PROJECT DETAILS – TELL US ABOUT YOUR PROJECT

PRINCIPAL FACADE

ARCHITECTURAL SURVEY	
VERSION 1	01
3747 Tyler Detroit	
PRINT A2 (16,5 x 23,375)	
DATE:

1 Sección 1 1 : 50

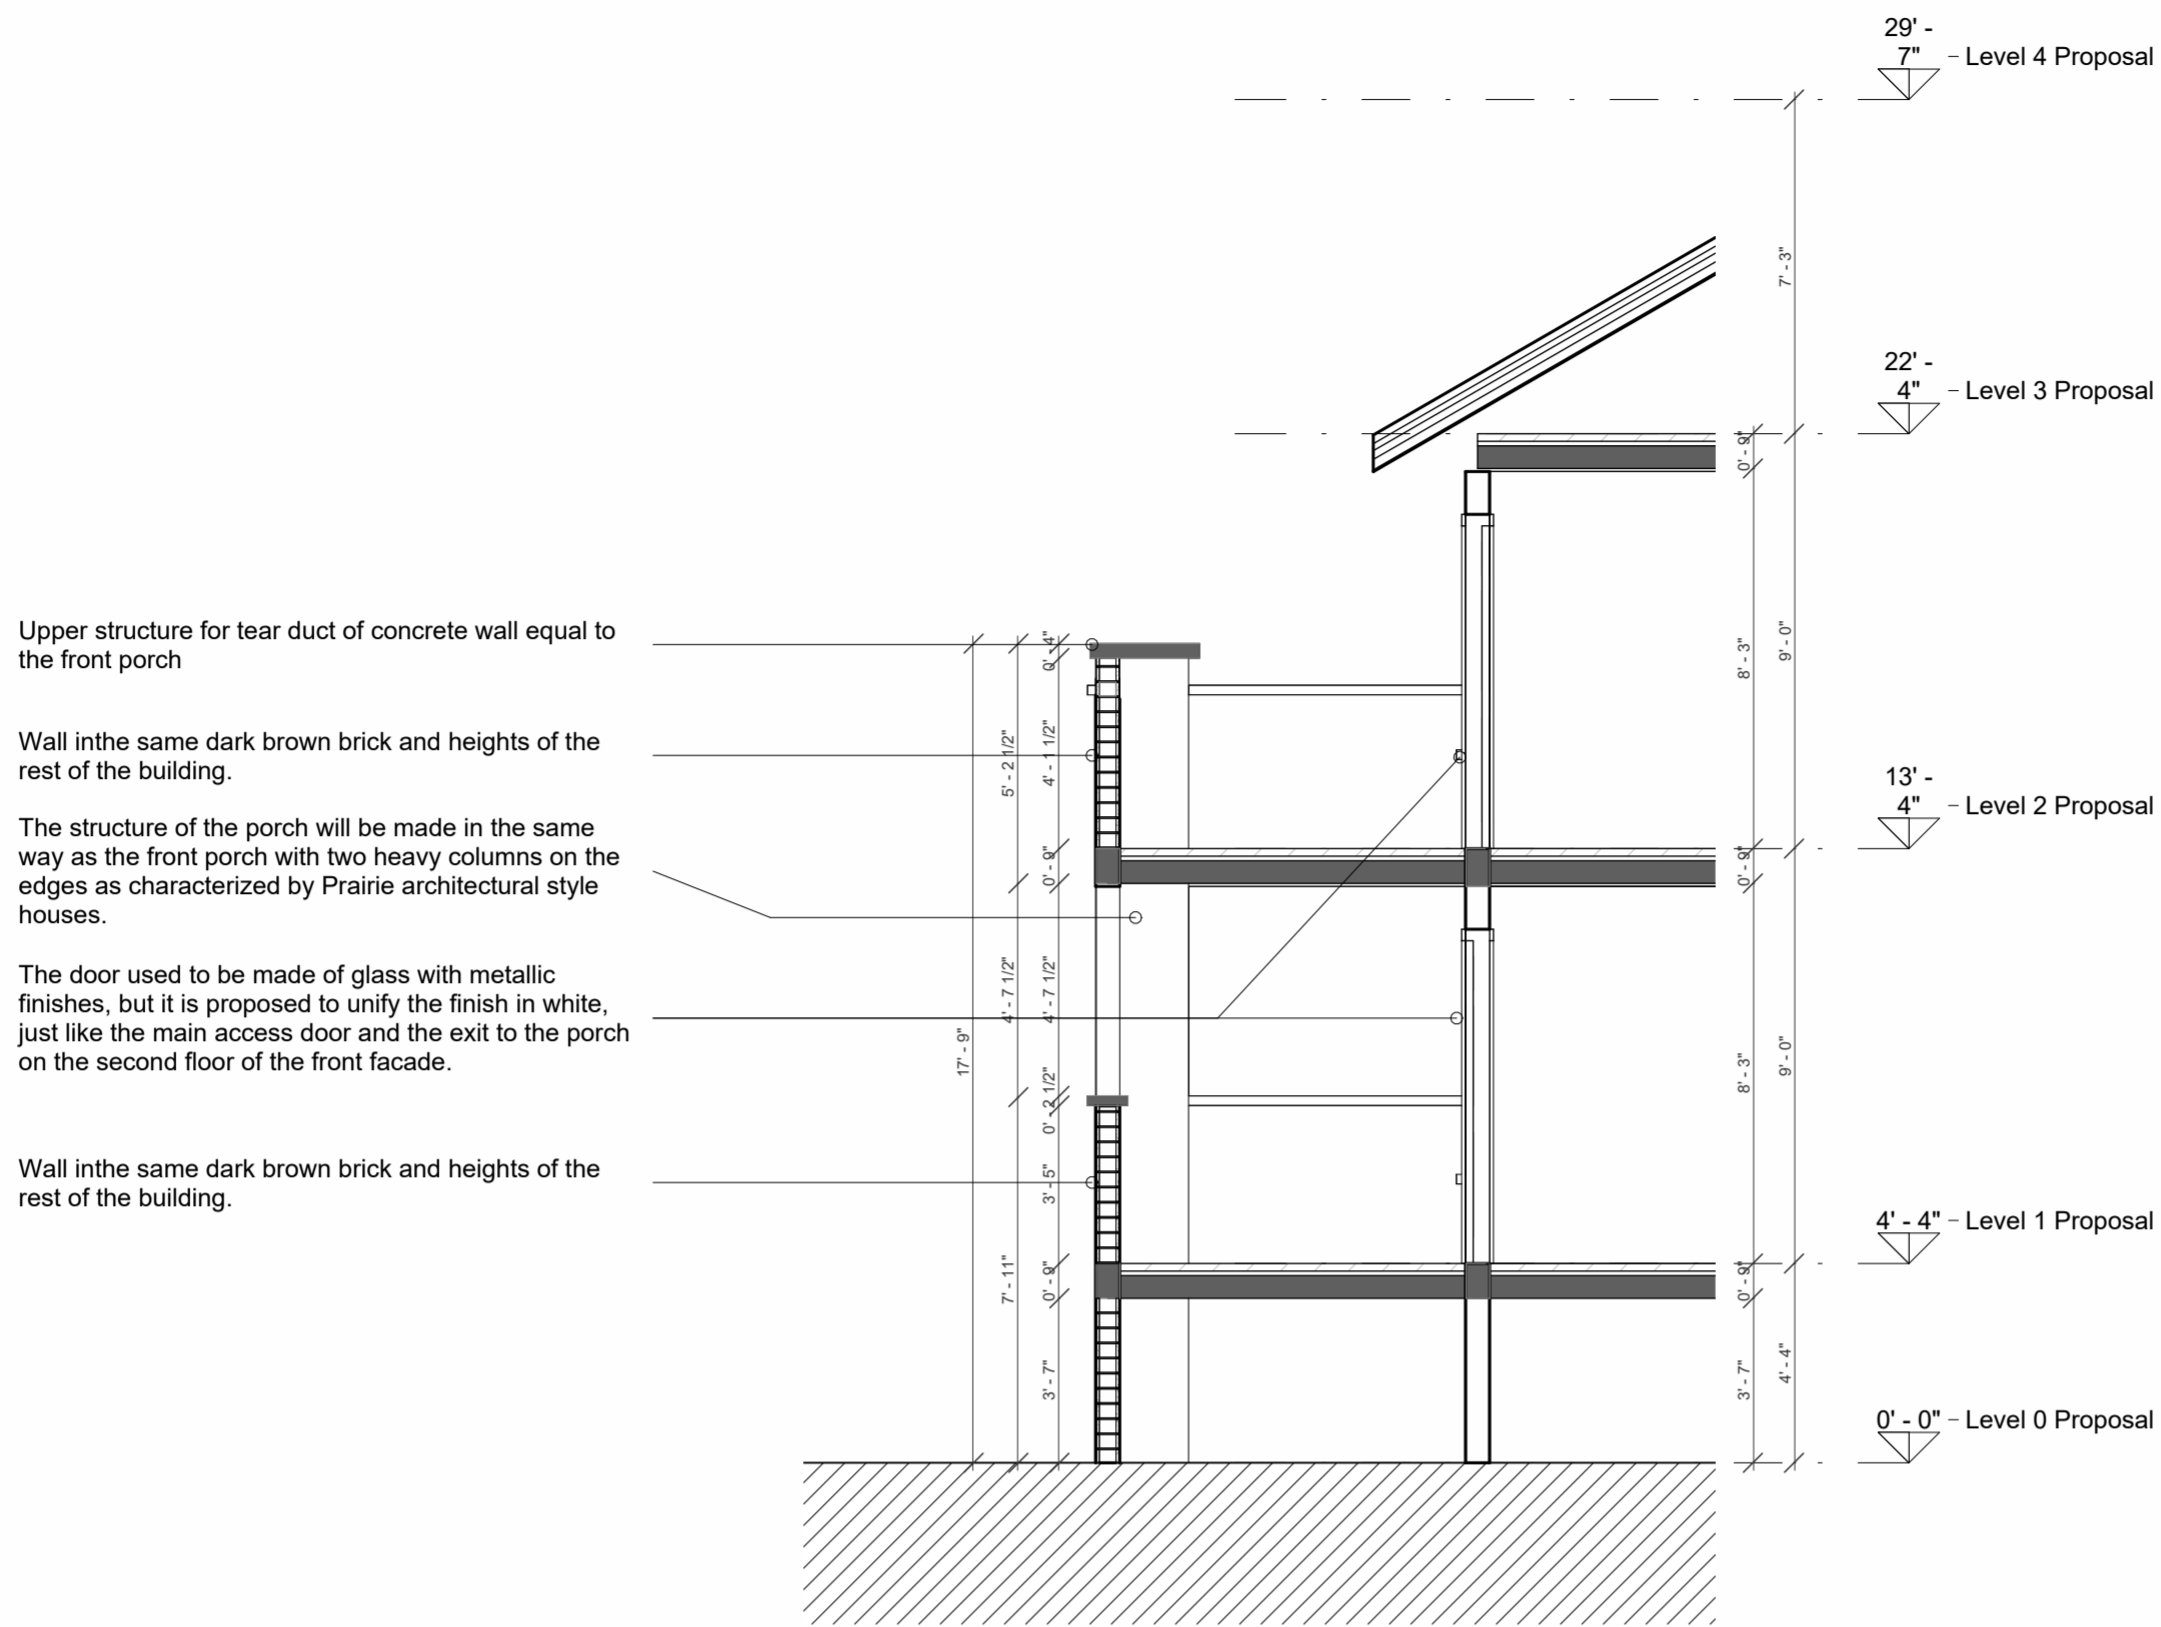
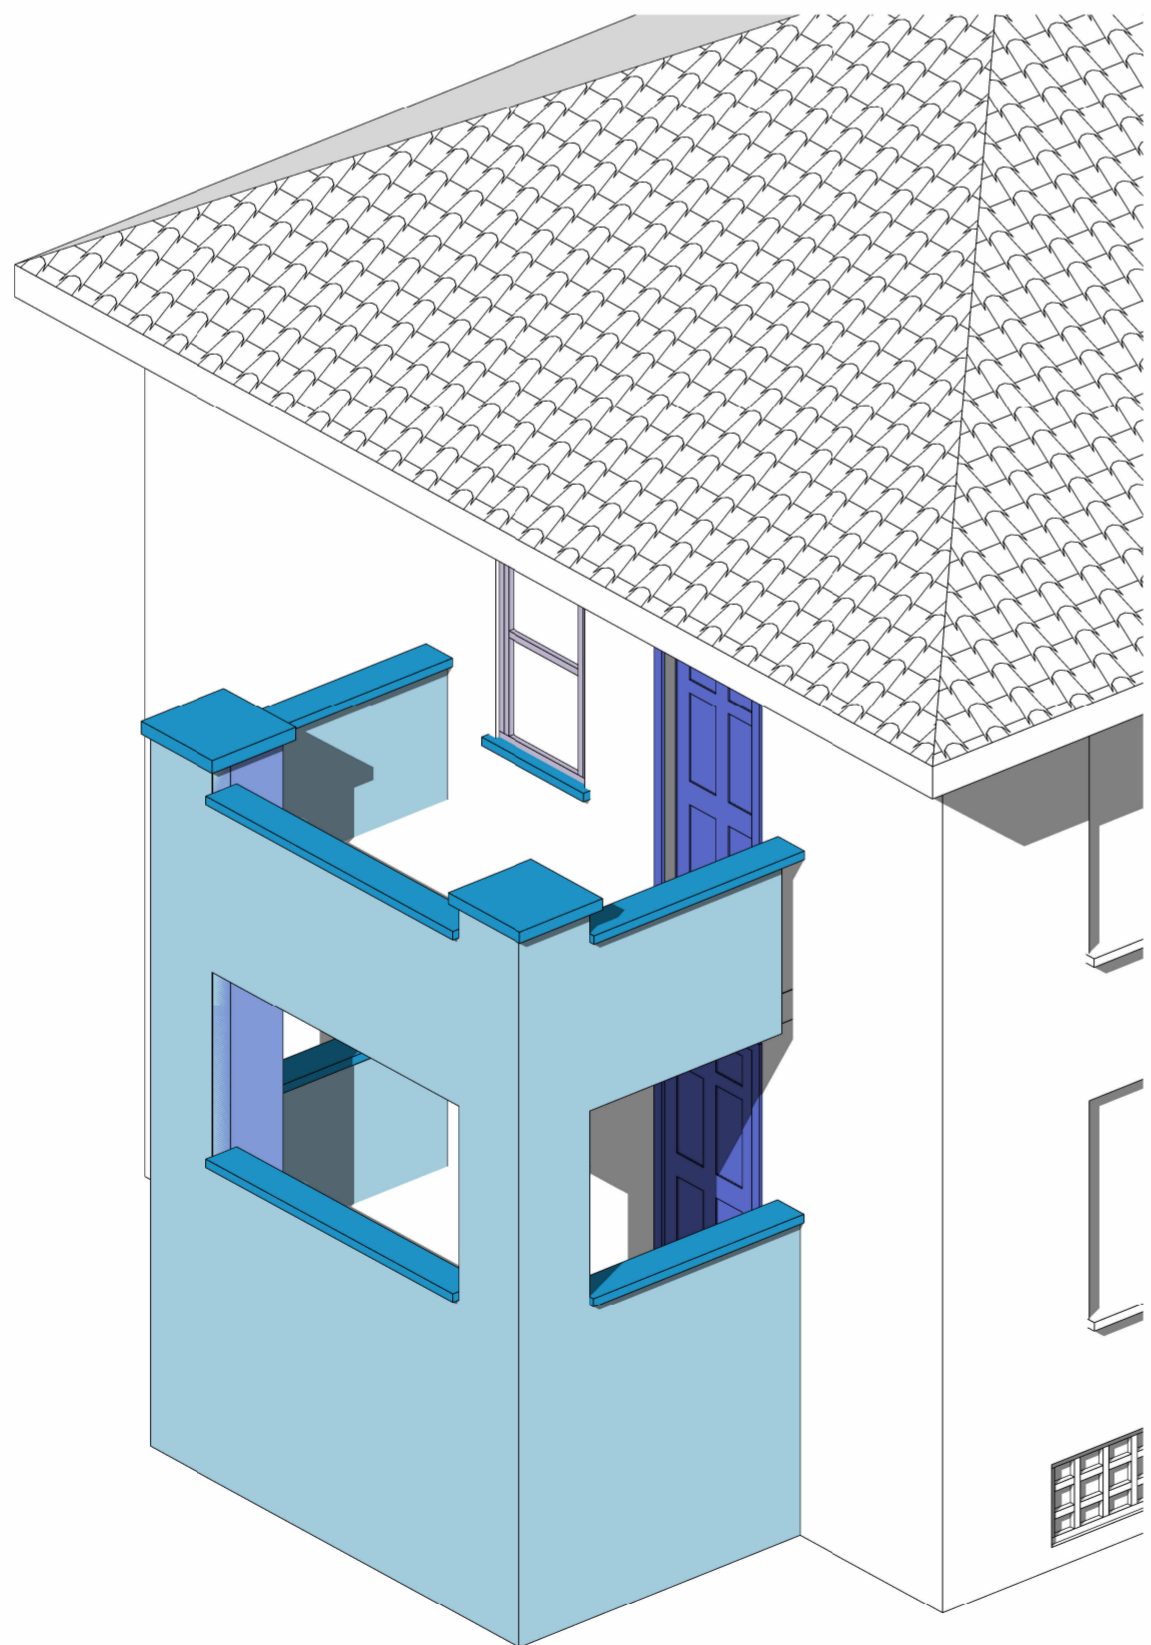
Upper structure for tear duct of concrete wall equal to the front porch

Wall in the same dark brown brick and heights of the rest of the building.

The structure of the porch will be made in the same way as the front porch with two heavy columns on the edges as characterized by Prairie architectural style houses.

The door used to be made of glass with metallic finishes, but it is proposed to unify the finish in white, just like the main access door and the exit to the porch on the second floor of the front facade.

Wall in the same dark brown brick and heights of the rest of the building.

- Upper structure for tear duct of concrete wall equal to the front porch
- Wall in the same dark brown brick and heights of the rest of the building.
- The structure of the porch will be made in the same way as the front porch with two heavy columns on the edges as characterized by Prairie architectural style houses.
- The door used to be made of glass with metallic finishes, but it is proposed to unify the finish in white, just like the main access door and the exit to the porch on the second floor of the front facade.
- single hung window using aluminum-clad wood windows frames over the vinyl window and paint them in yellowish white color as is specify in the color system E.
